Troy Schools District

**RFP #2324-22
BP#3B Smith Middle School - ARCH & MEP & Civil -
Addendum #2
July 15th, 2024**

Troy Schools District – BP#3B Smith Middle School – ARCH & MEP & Civil – Addendum #2

Addendum #2 Bidder Clarifications

PROJECT NO.
22102
DRAWING NO.
C-3.1

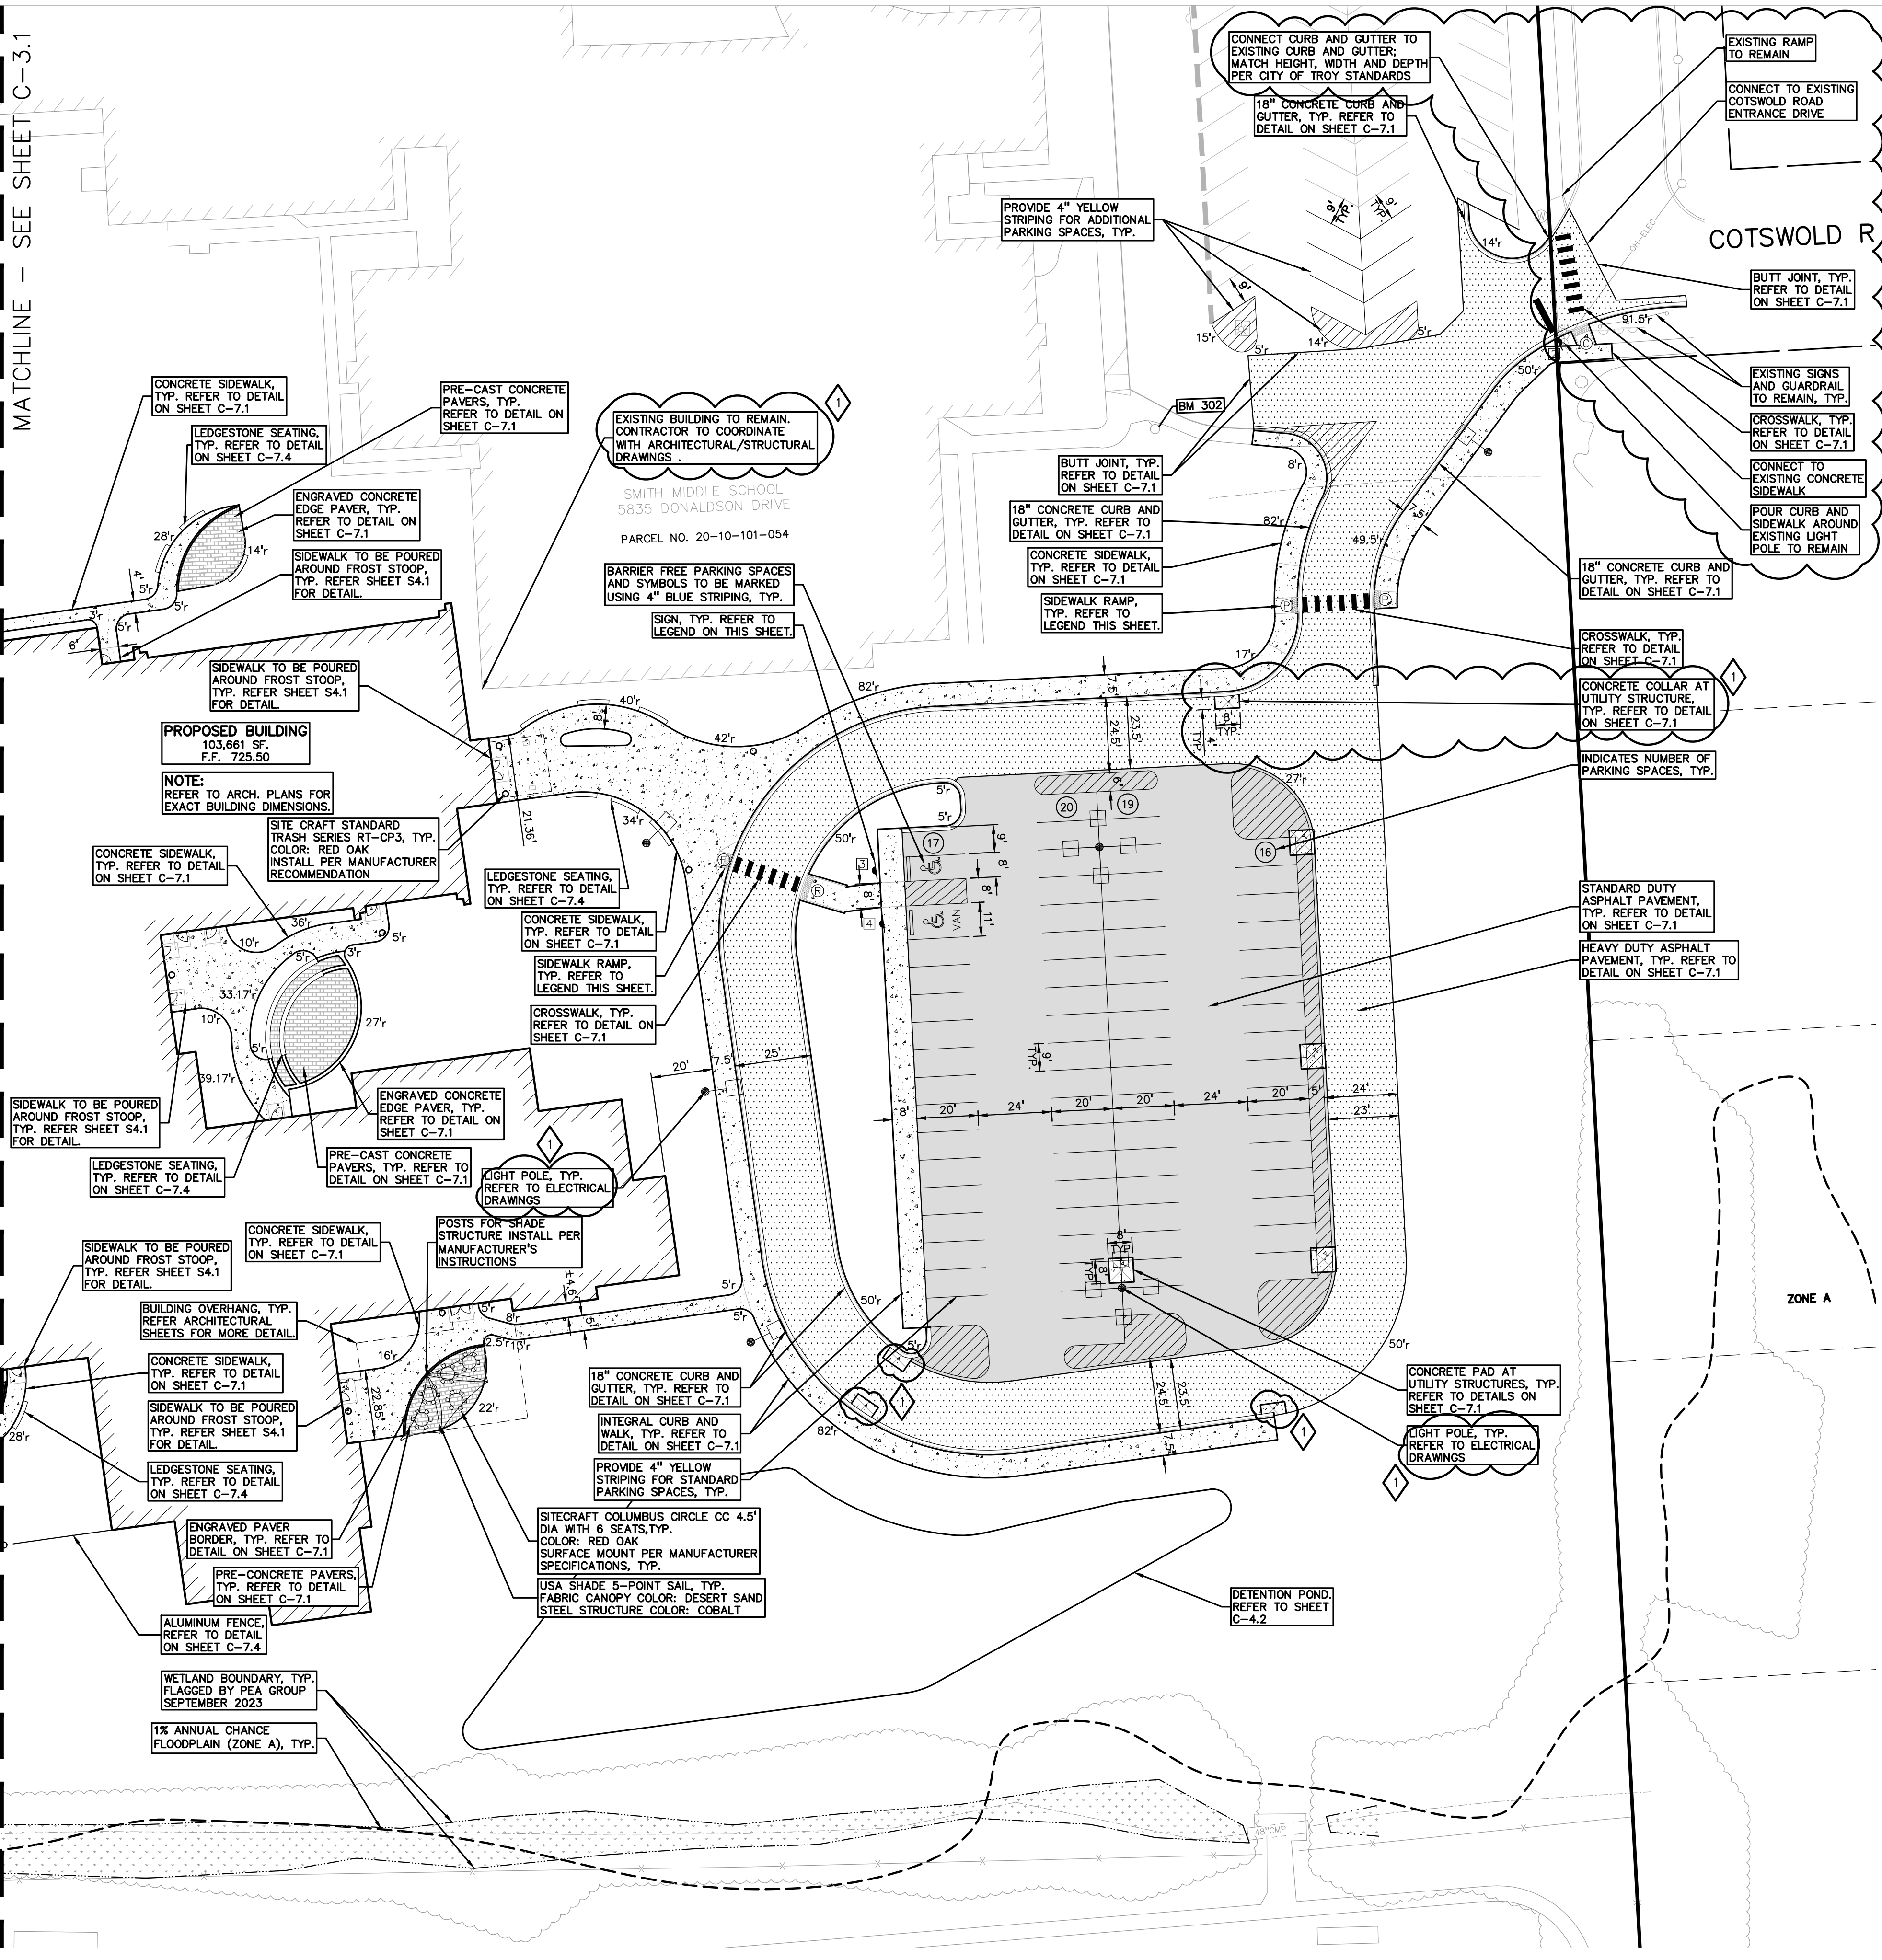
- CD-4 Refer to Drawing No. C-3.1 – Dimension & Paving Plan – West (reissued):
- A. Added culverts beneath the entry drives as indicated.
 - B. Added concrete pads at utility structures as indicated.

- C. Added note indicating the curb taper at the ADA parking spaces as indicated.
 - D. Added note indicating the flush concrete sidewalk at the east side of the parking lot as indicated.

DRAWING NO.
C-3.2

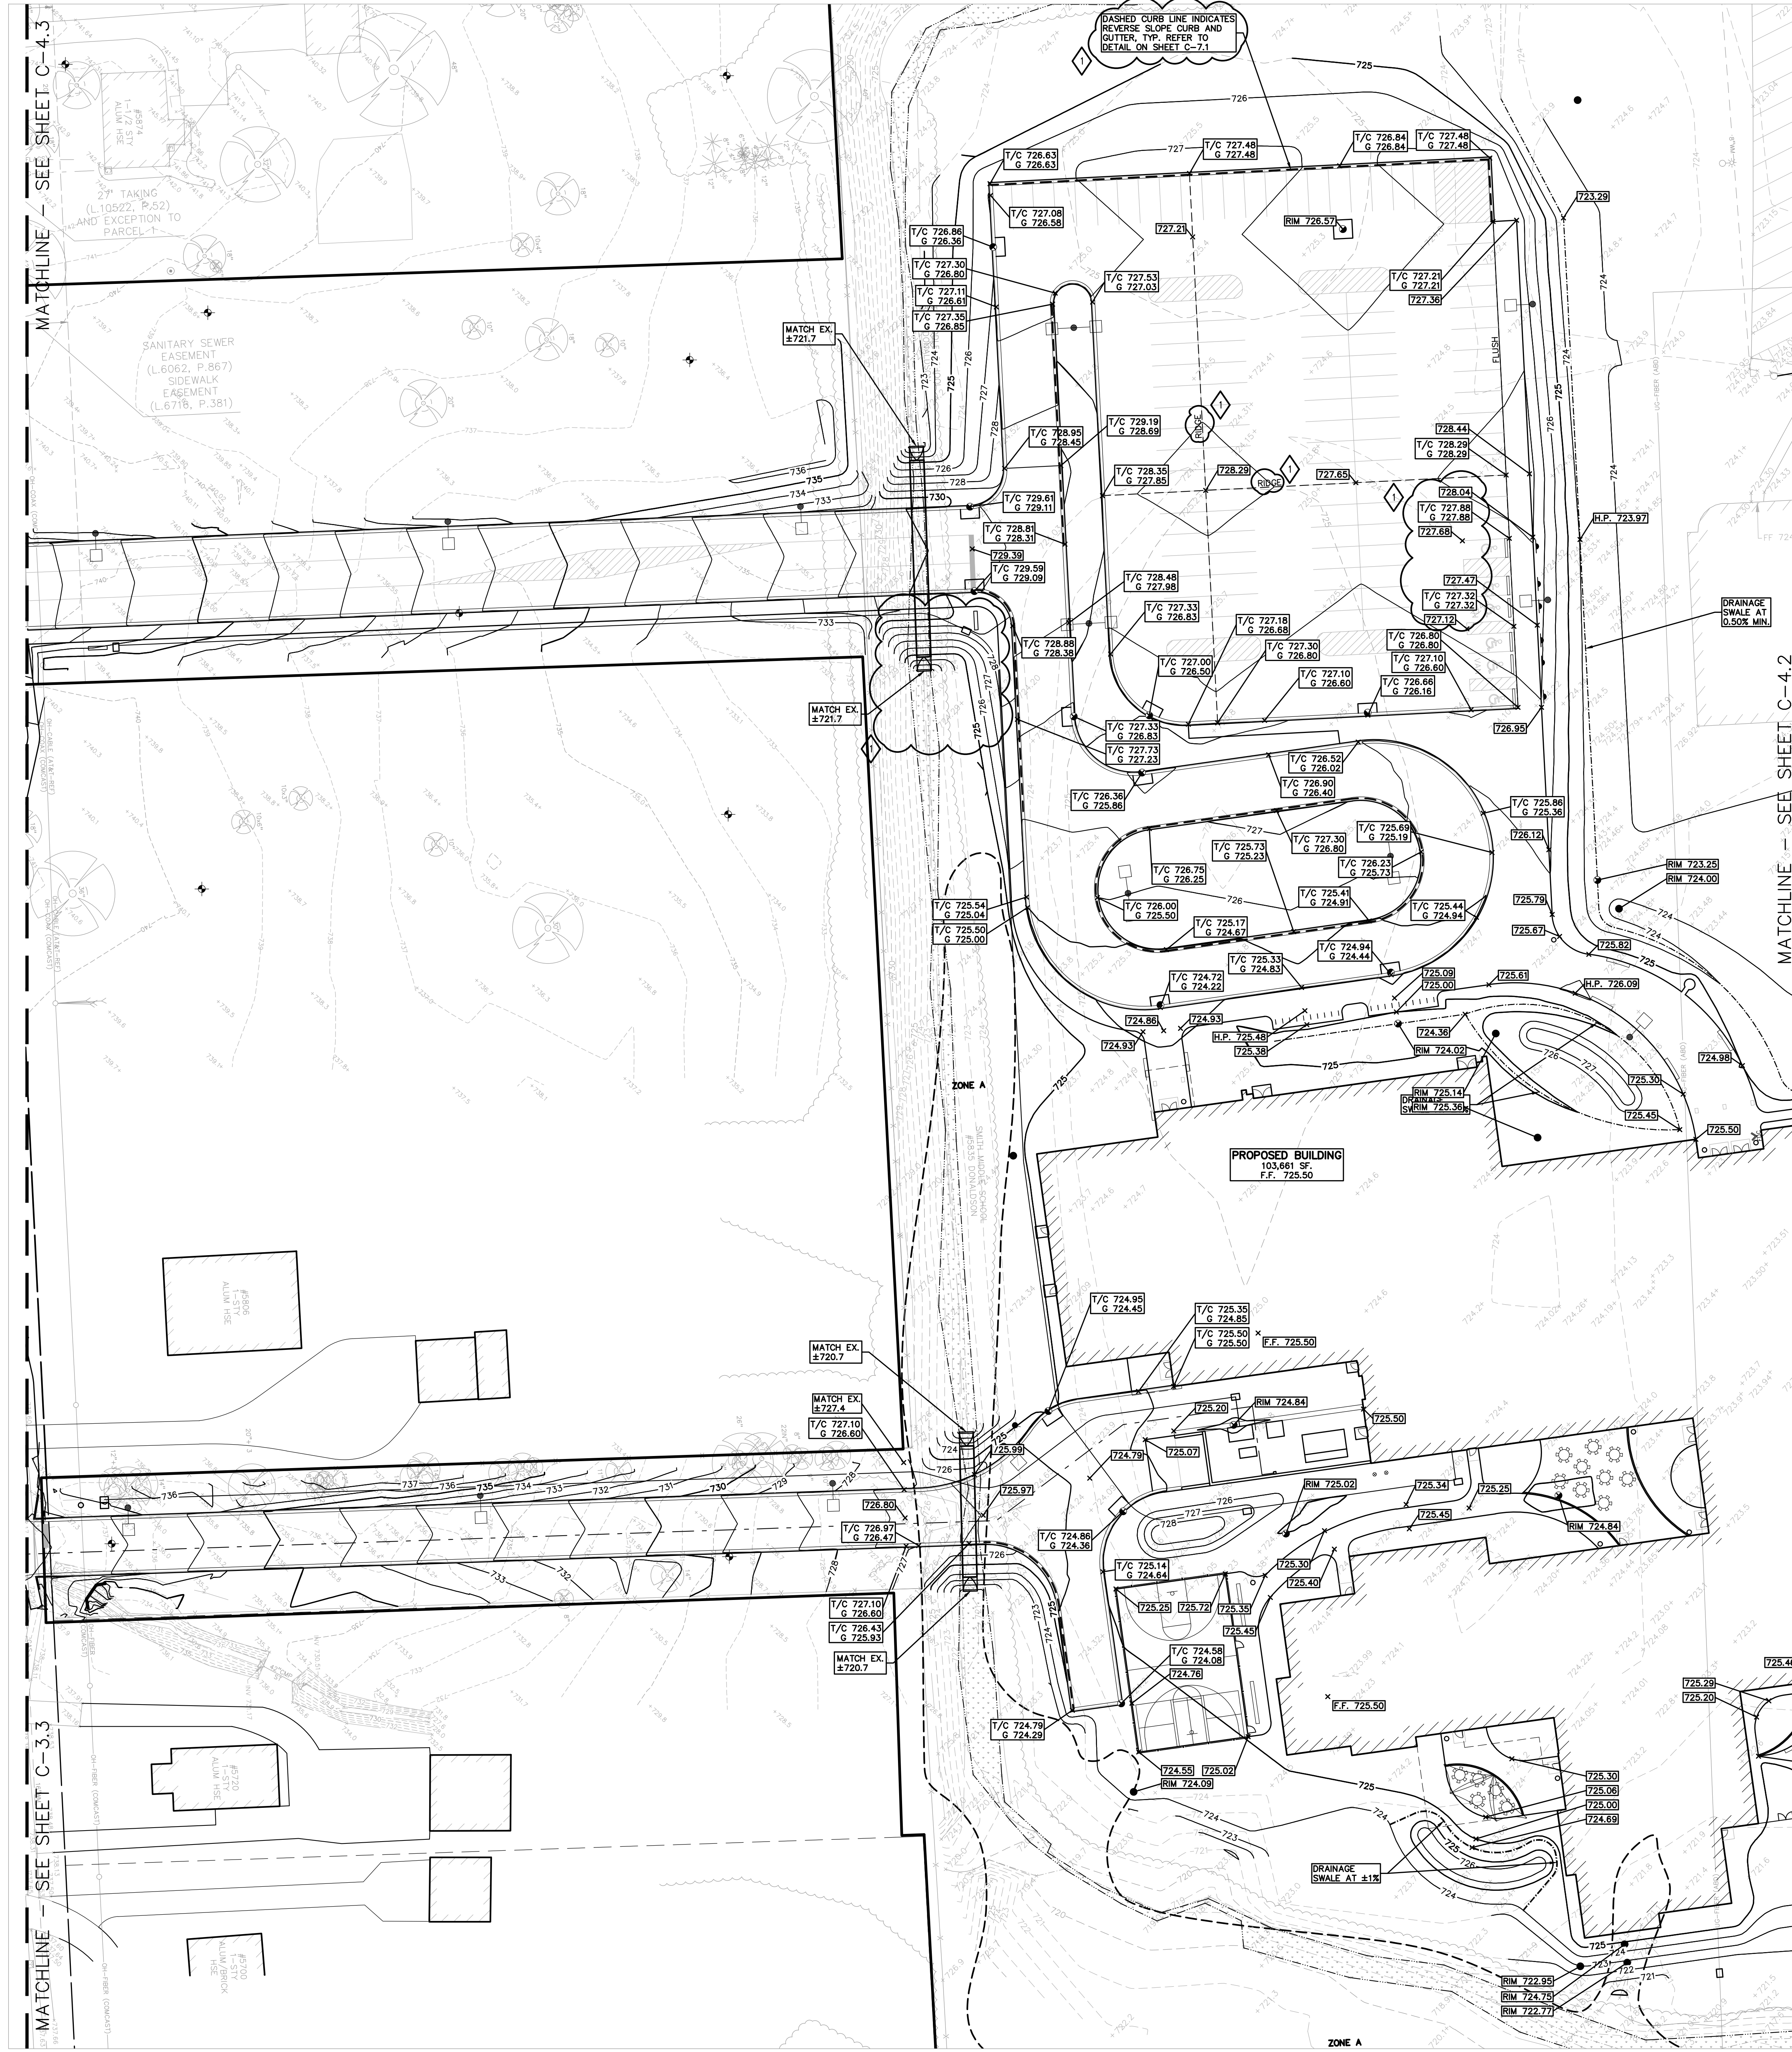
- CD-5 Refer to Drawing No. C-3.2 – Dimension & Paving Plan - East (reissued):
- A. Added concrete pads at utility structures as indicated.
 - B. Added notes indicating the light poles as indicated.

PROJECT NO.
22102
DRAWING NO.
C-4.2

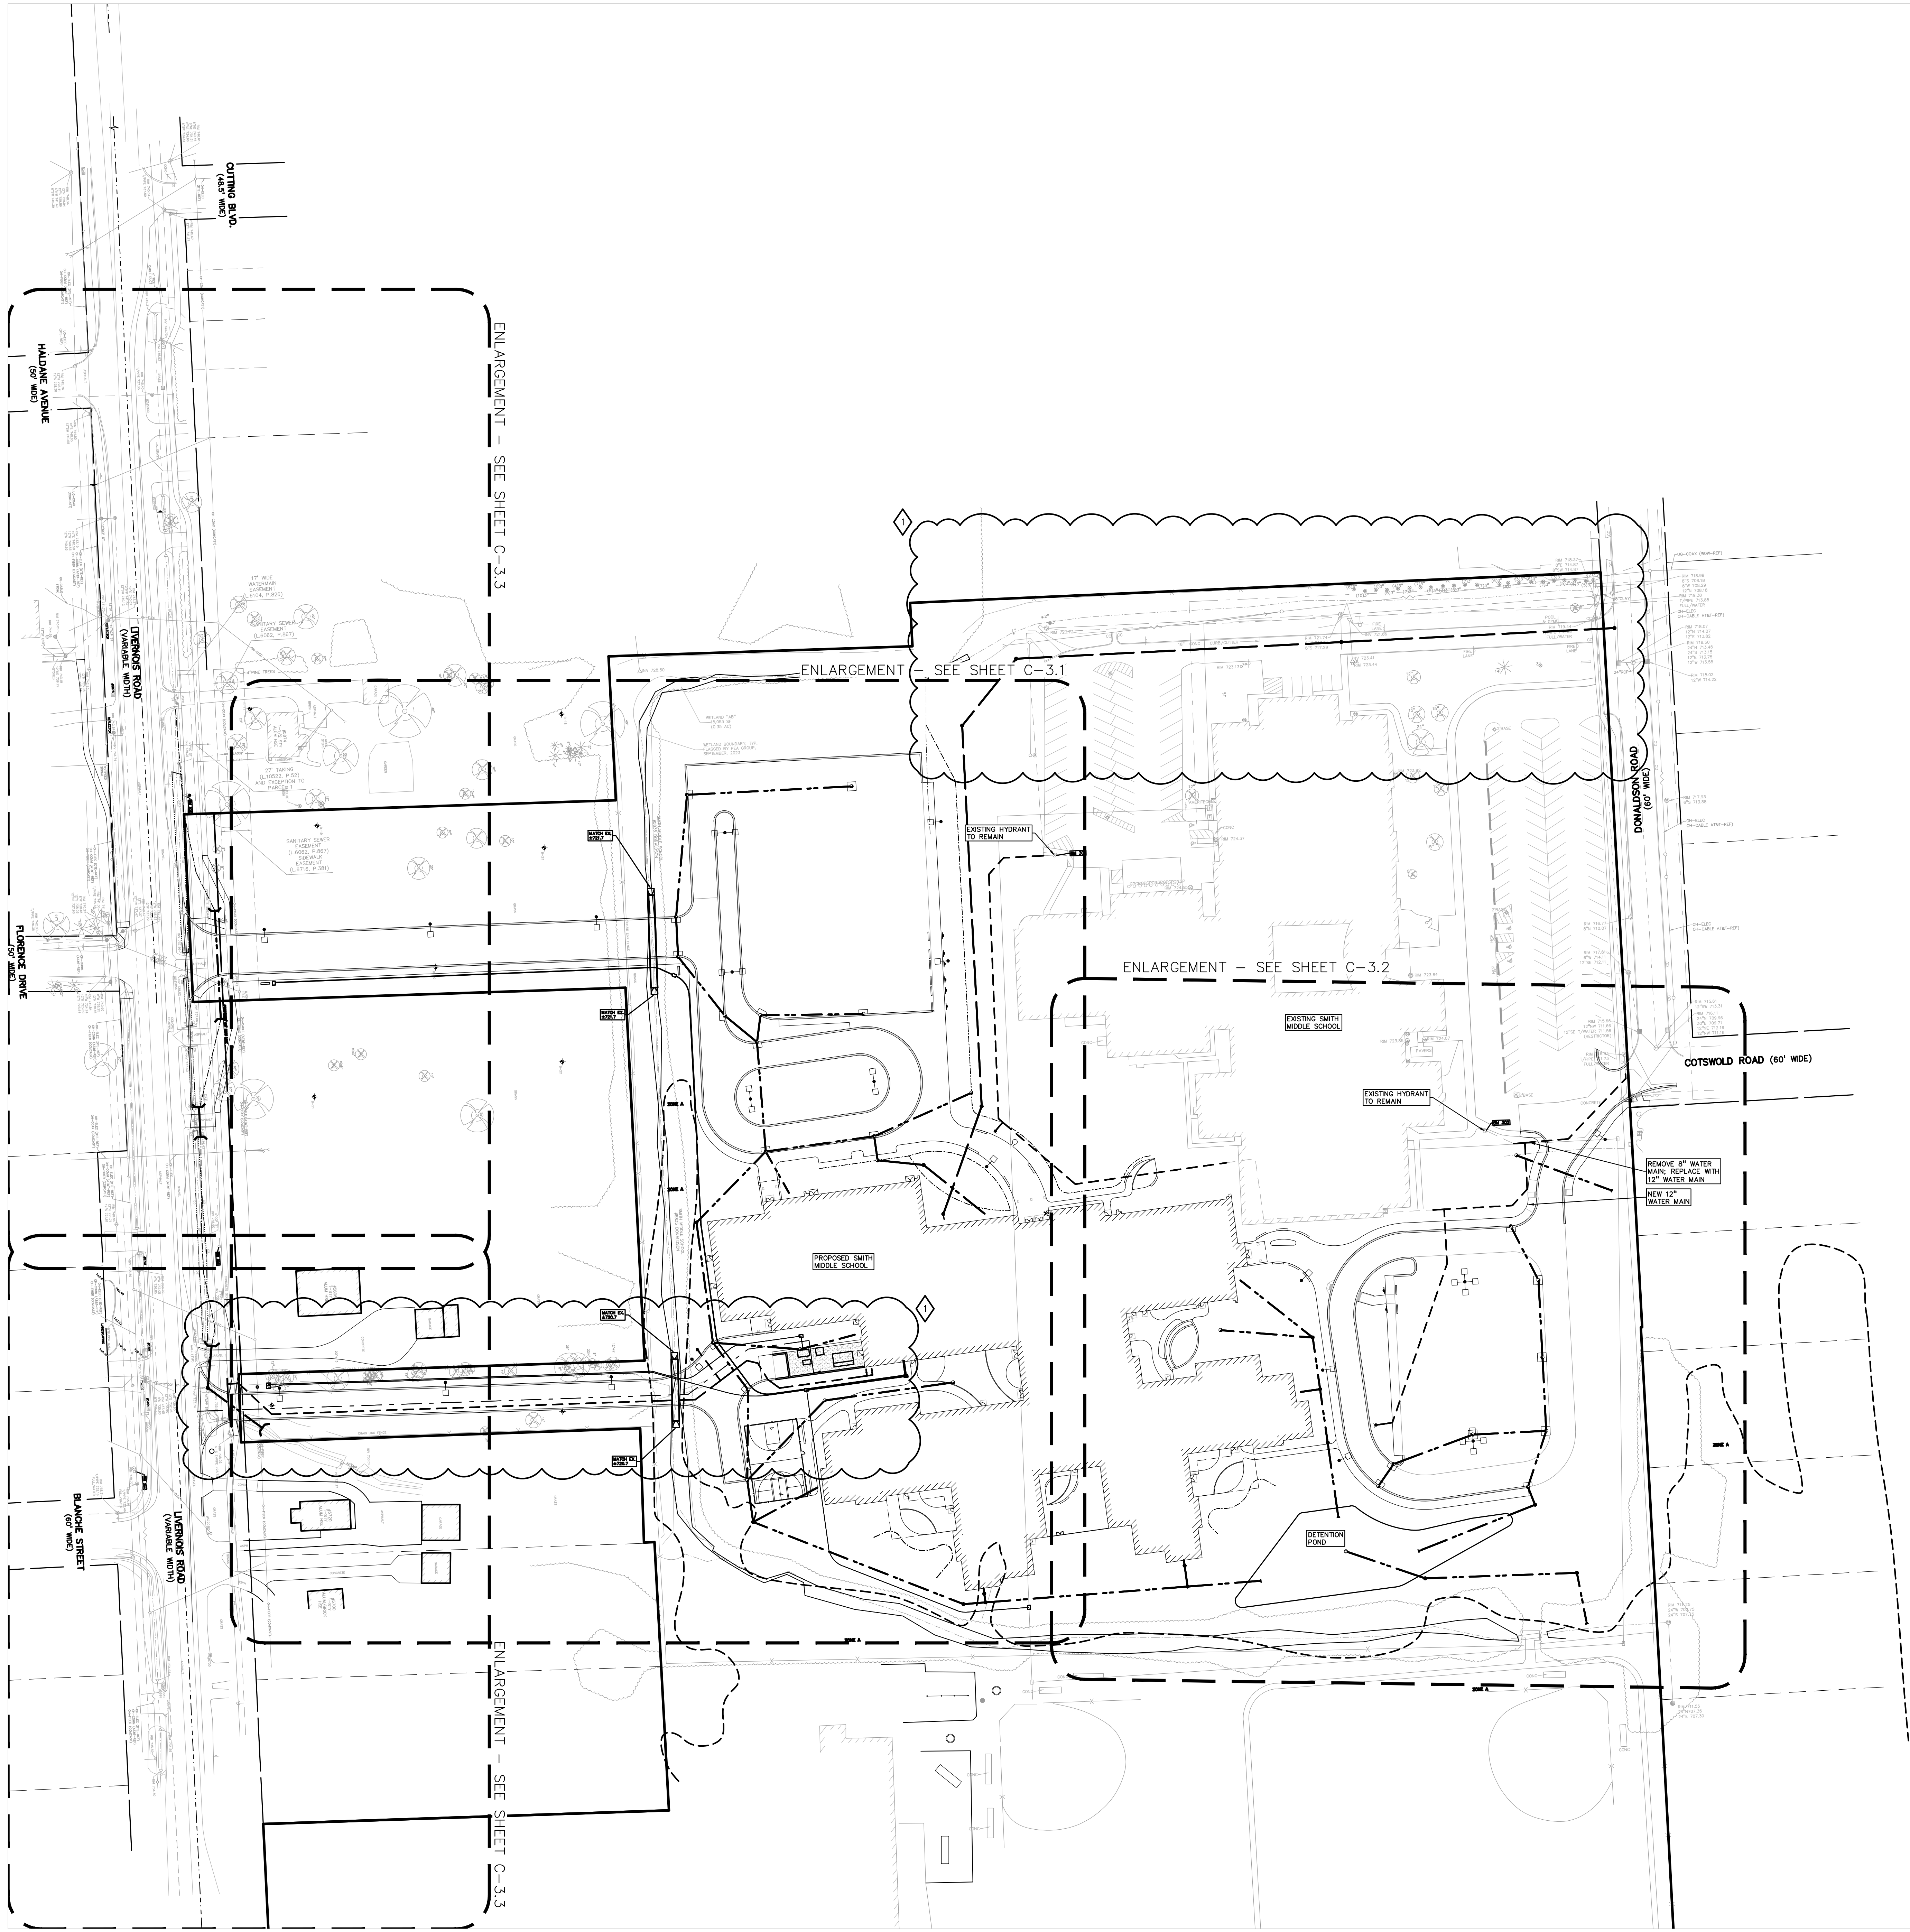
- CD-7 Refer to Drawing No. C-4.2 – Grading Plan - East (reissued):
- A. Added additional spot elevations at the ADA parking area as indicated.
 - B. Added/Revised spot elevations at the entrance to Cotswold Road as indicated.

- C. Added notes referring to the geotechnical investigation and the ground improvement bid package as indicated.
- CD-8 Refer to Drawing No. C-5.0 – Overall Utility Plan (reissued):
